**World Forum for Harmonization of Vehicle Regulations****Working Party on Brakes and Running Gear****Seventy-sixth session**

**Motorcycle braking – Global Technical Regulation No. 3****Proposal for amendments to Global Technical Regulation  
No. 3 (Motorcycle brake systems)****Submitted by the expert from Italy\***

The text reproduced below was prepared by the expert from Italy to introduce amendments to clarify the text of the Regulation. This proposal incorporates ECE/TRANS/WP.29/GRRF/2013/33, amended by GRRF-75-32 and addresses the comments received during the seventy-fifth GRRF session. The modifications to the current text of the Regulation are marked in bold for new or strikethrough for deleted characters.

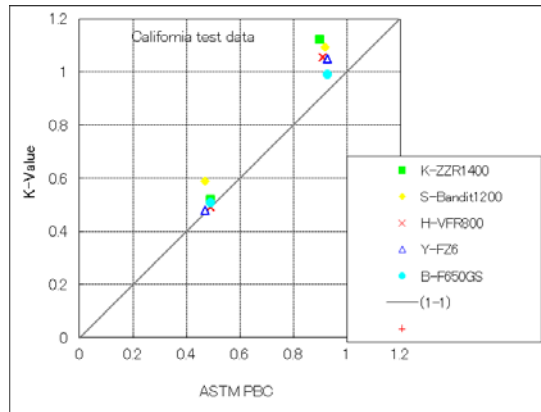
(c) During the discussions on UN GTR No.3, the correlation test between K-method and ASTM method was performed in California. The data from the test are shown in the graph below.

PBC values by K-method were for same test course, and the following were recognized.

- PBC values were different for the measuring motorcycle (tyre).
- Such level of difference should be permitted.

Even for the same course, PBC values were found to be different for each motorcycle. It was noted that it is beneficial to measure the PBC values of the course using the same motorcycle to maintain the course PBC value condition.

The proposal from Italy includes a condition saying that when choosing the motorcycle, correlation level of the motorcycle for K-method to ASTM method should be confirmed. Italy believes that the motorcycle with the same correlation level as the California test result can be a representative vehicle for use in measuring PBC values of the course.

**Note 1: A representative vehicle may be acceptable for PBC measurement by method (b) if that vehicle has shown the same nominal PBC on both high  $\mu$  and low  $\mu$  as previously determined by method (a).**

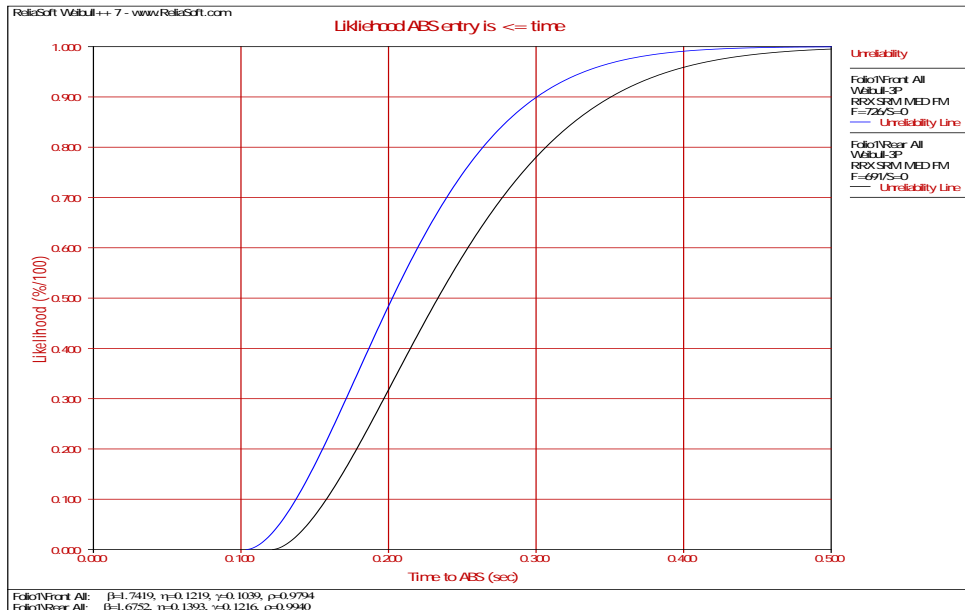
It has been noticed in testing that the brake application rate specified in paragraph 4.9.5.1 can result in a large number of test failures. It can be seen in the chart below that the 0.2 second lower limit shows a failure rate is between 30 per cent and 50 per cent of the time.

By reducing the lower limit to 0.1 seconds the test failure rate reduces to practically zero. Allowing the reduction tends to make the regulation more stringent by including a greater number of brake force application rates and eliminates restrictive test requirements.

The brake control actuation force is applied in **0.1 – 0.5** seconds."
